246 RIVERBANK ROAD WIND MACHINE REVERSE SENSITIVITY

I have reviewed the report prepared by Marshal Day Acoustic (MDA) entitled Riverbank Road Wind Machine, Reverse Sensitivity Analysis, Rp 001 20190612 dated 10 September 2019. This report makes recommendations to ensure the proposed residential development does not result in a reverse sensitivity effect for you. I agree with the approach taken by MDA requiring any new dwelling to take into account noise from the wind machine. I also agree there is not a significant difference in the actual noise level produced by the existing Defender wind machine and a Frost Boss C59 five blade machine. However, the Defender machine does have a special audible characteristic to the sound while the C59 does not. Thus, there is a benefit for future neighbours if the existing Defender wind machine blades are replaced with a Frost Boss C59 five blade fan. The effect of this will be to reduce the number of future dwellings that need to have an acoustic design included and where an acoustic design is necessary the required sound reduction will not be as stringent for the Frost Boss C59 as it would be for the Defended machine.

Figure 1. Predicted Wind Machine noise contours

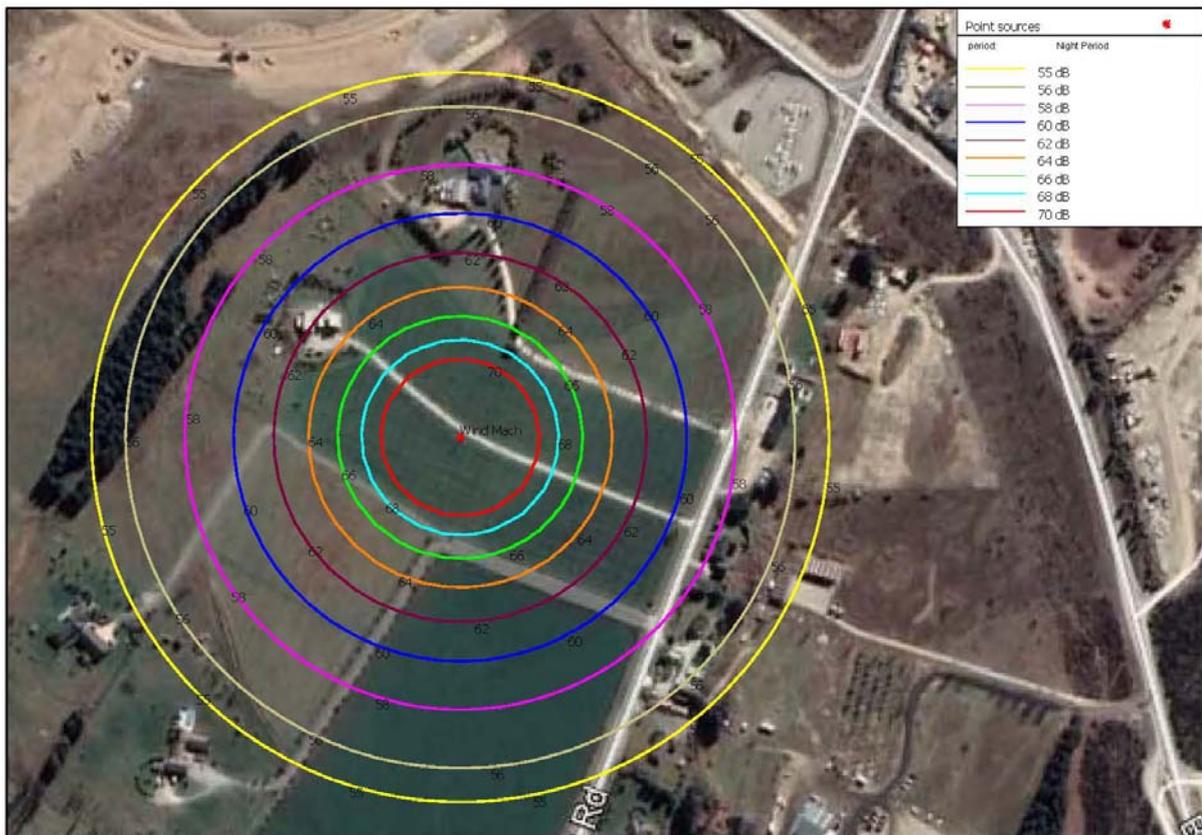
To provide guidance on the dwellings that may require specific acoustic treatment the distance from the wind machine that a typical dwelling should be so the design level of 30dB $L_{Aeq(15 \text{ min})}$ inside needs to be determined. Based on field measurements of the typical lightweight dwelling construction a sound reduction in excess of 25dB $L_{Aeq(15 \text{ min})}$ (typically 27 - 28dB) will be achieved with the windows closed when assuming 4mm single glazing in timber joinery. That is, to achieve a level of no more than 30dB $L_{Aeq(15 \text{ min})}$ inside the dwelling then the outside level should not exceed 25dB + 30dB = 55dB $L_{Aeq(15 \text{ min})}$. An external level of 55dB $L_{Aeq(15 \text{ min})}$ will not be exceeded at any distance greater than 250m from the wind machine so by adopting 250m as the design limit will ensure the internal design limit of 25dB $L_{Aeq(15 \text{ min})}$ will be achieved. This assumes slightly positive meteorological conditions, a ground absorption of 0.7 and no screening of the wind machine.

- iii) *The acoustic design must be based on the noise contours as shown in Figure 1;*
- iv) *An acoustic design report must be provided to the Queenstown Lakes District Council's Team Leader Monitoring prior to any building consent being granted. The acoustic design report must be prepared by a person qualified and experienced in acoustics and demonstrate the means by which the noise limits specified in this rule will be complied with;*

- i) *Any new dwelling, visitor accommodation or other habitable building located within 250 metres of the wind machine not within the same site must be designed and constructed so that within the external building envelope surrounding any bedroom (when the windows are closed), the internal level does not exceed 30dB $L_{Aeq(15 \text{ min})}$;*
